❖ ADDENDUM NO. 1 ❖

**◆
A NEW BUILDING**

SANDOVAL COUNTY RECREATION CENTER

Please note this Addendum forms a part of the Contract Documents and modifies them in the manner and extent set forth below. All other contents, terms, and conditions of the Documents remain unchanged.

A401

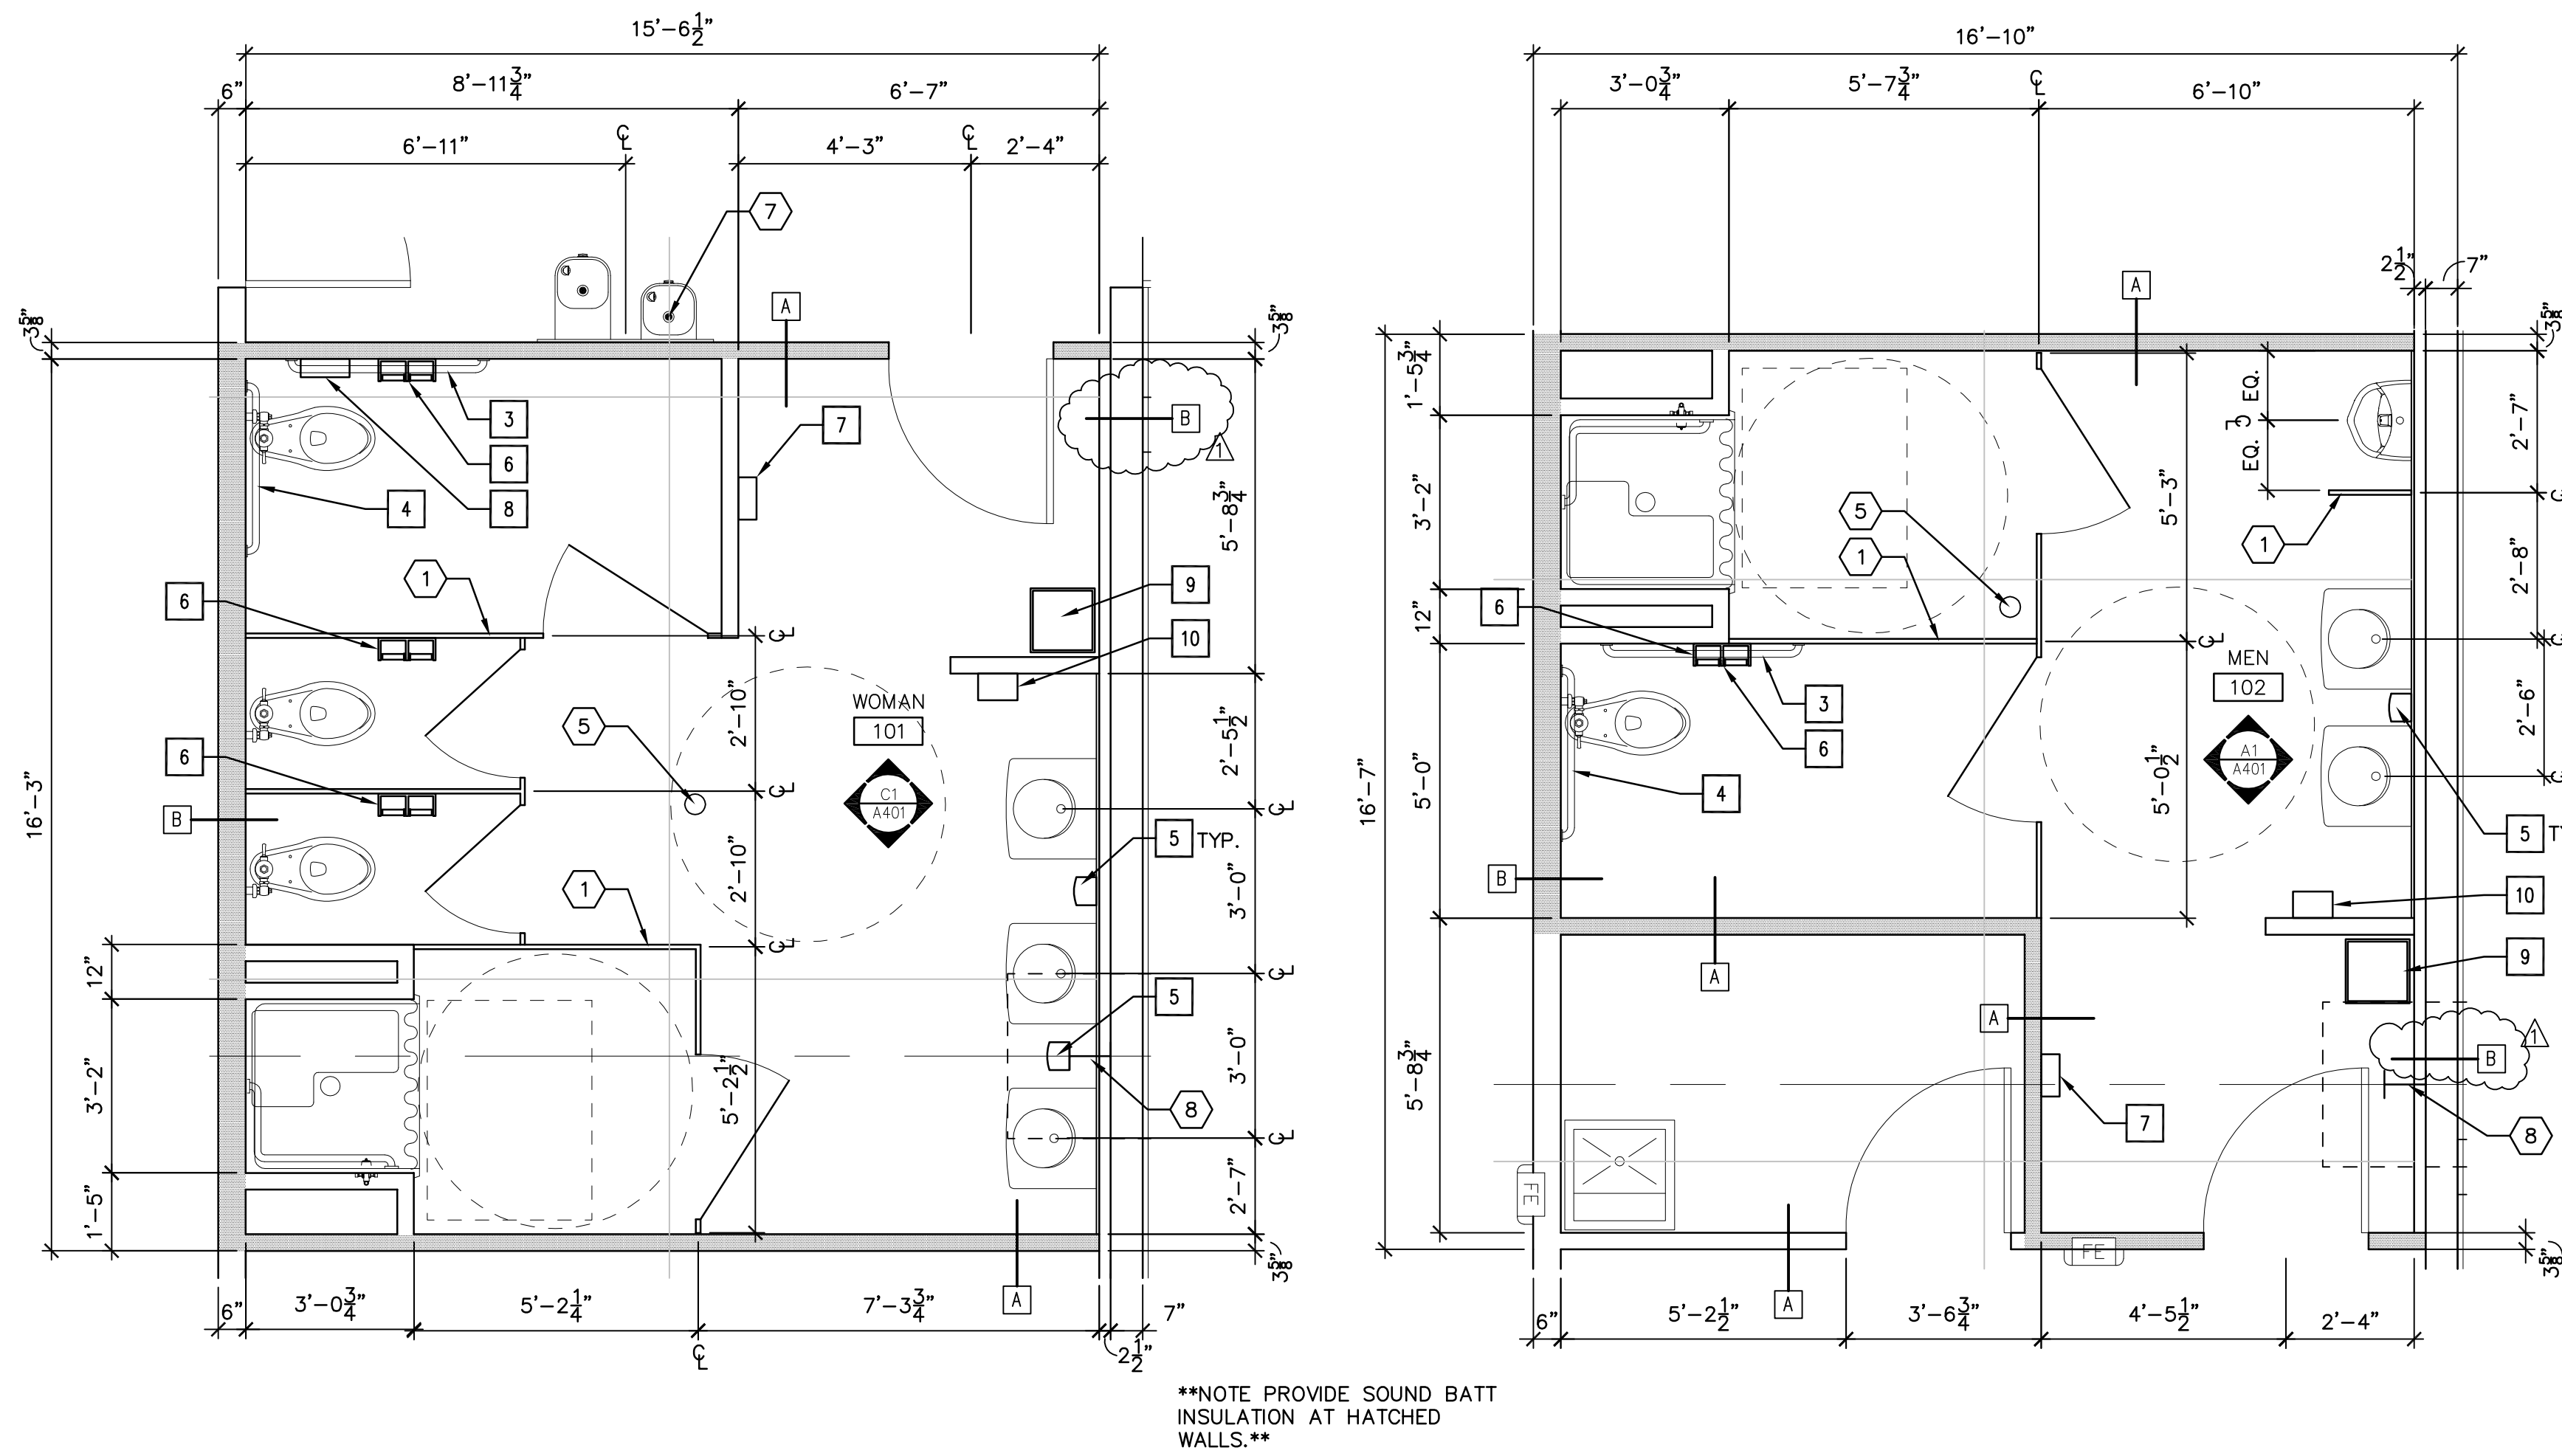
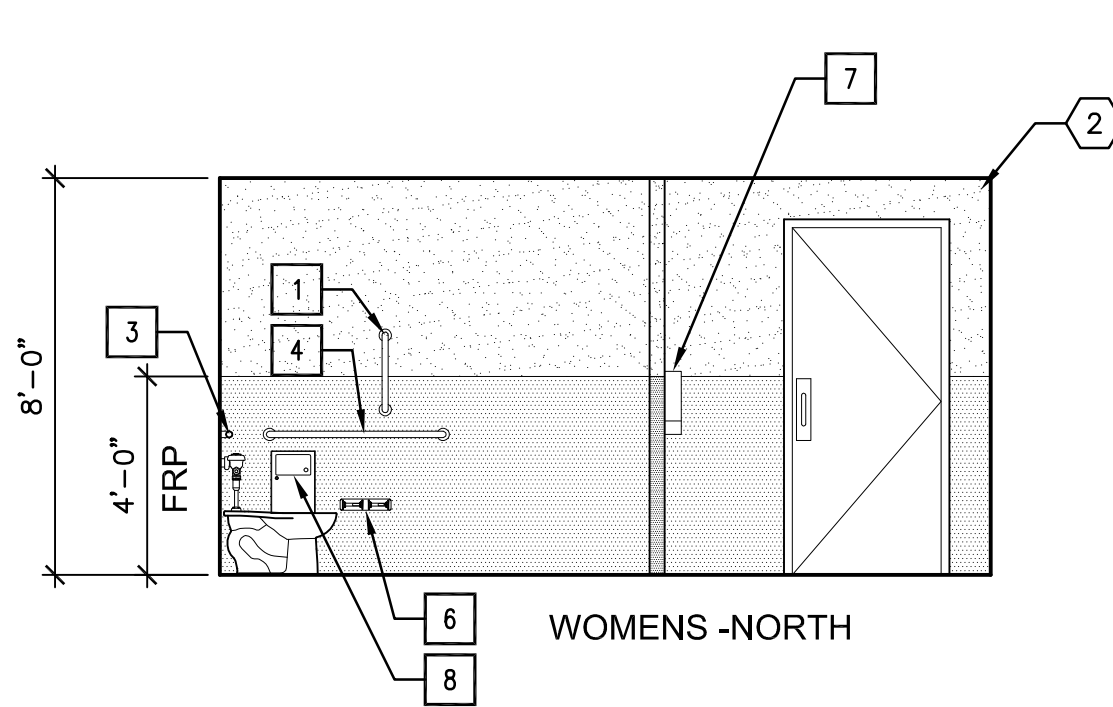
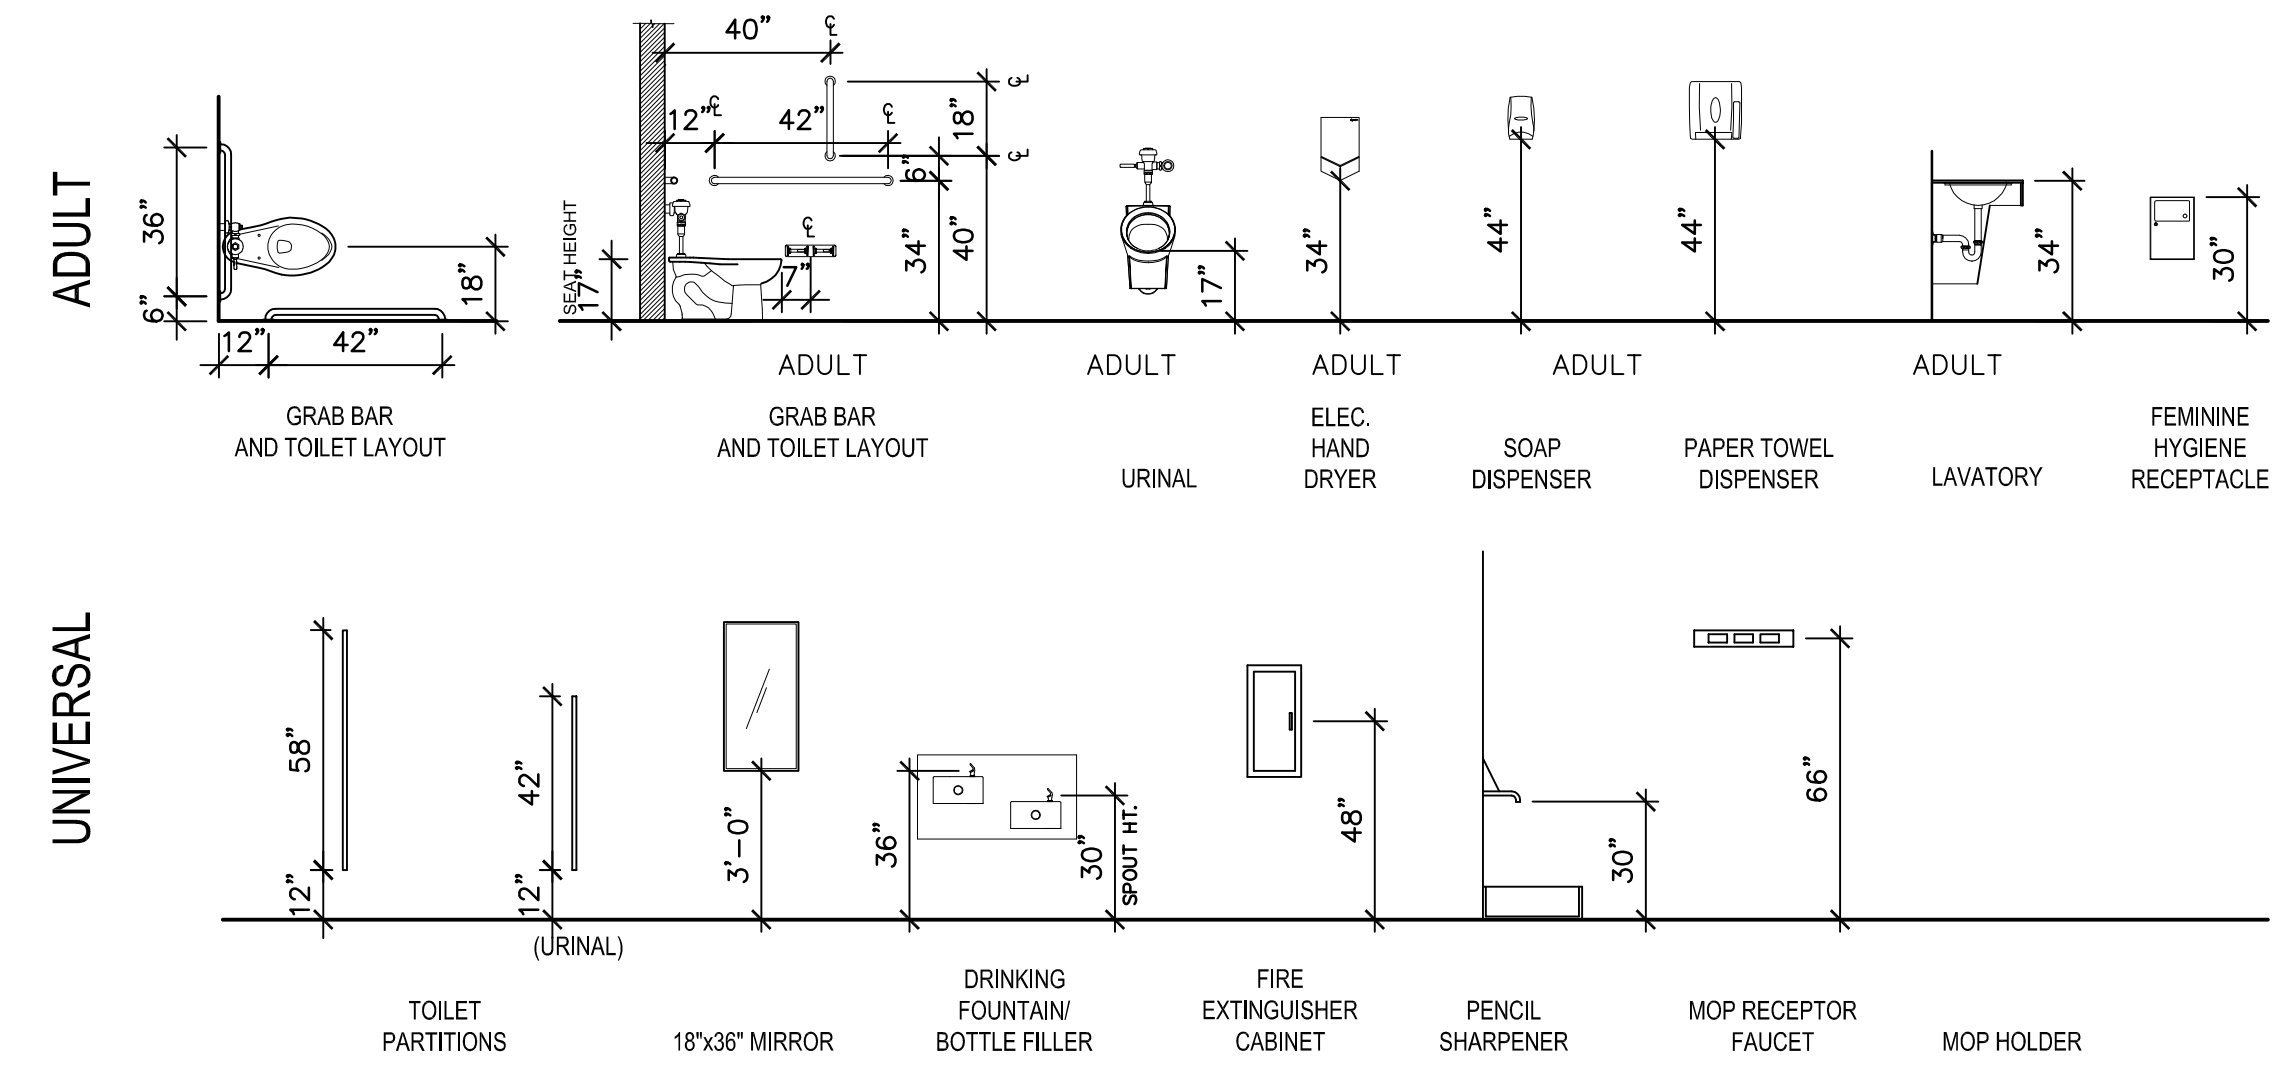
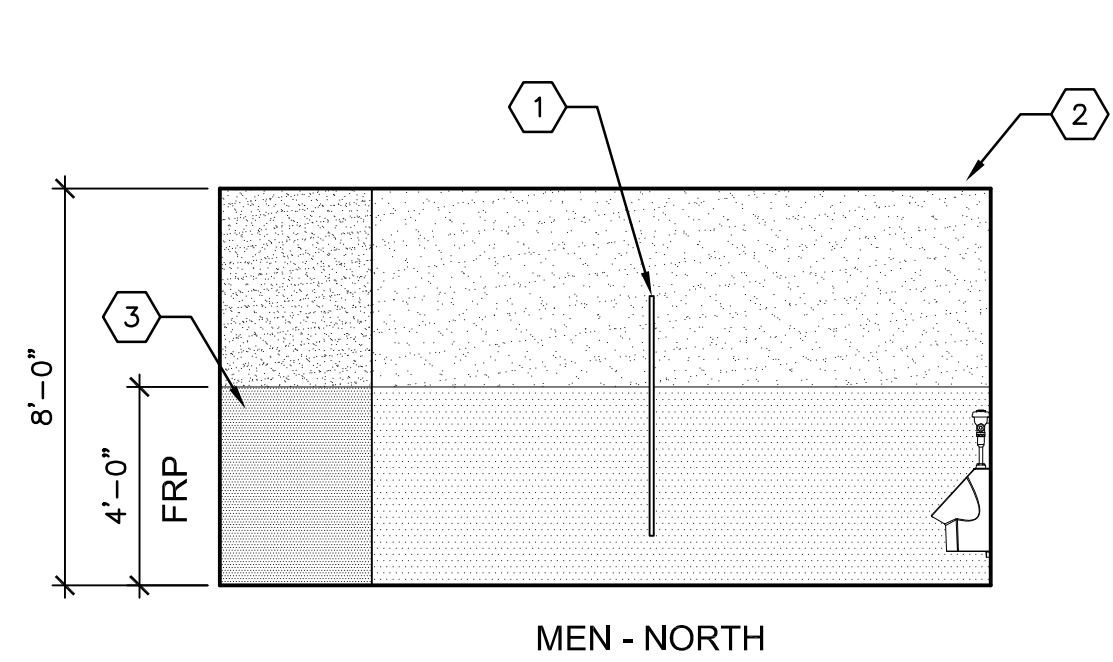
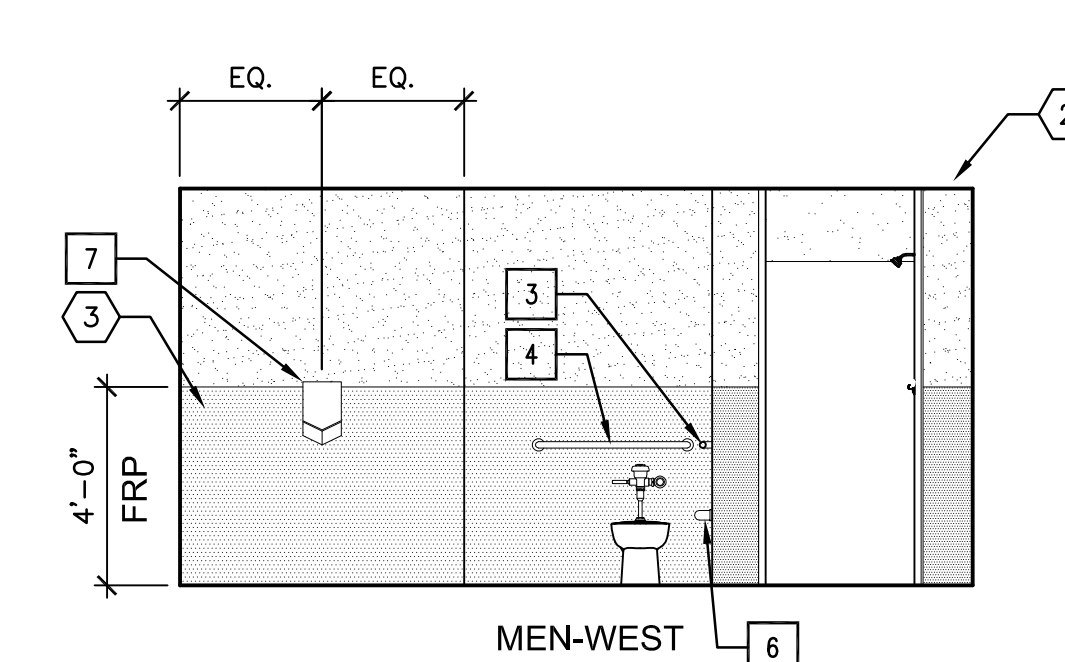
A. Sheet A401, Enlarged Plans & Interior Elevations

1. Change East toilet walls to be 6" steel studs. Now wall type 'B', (not type 'C').
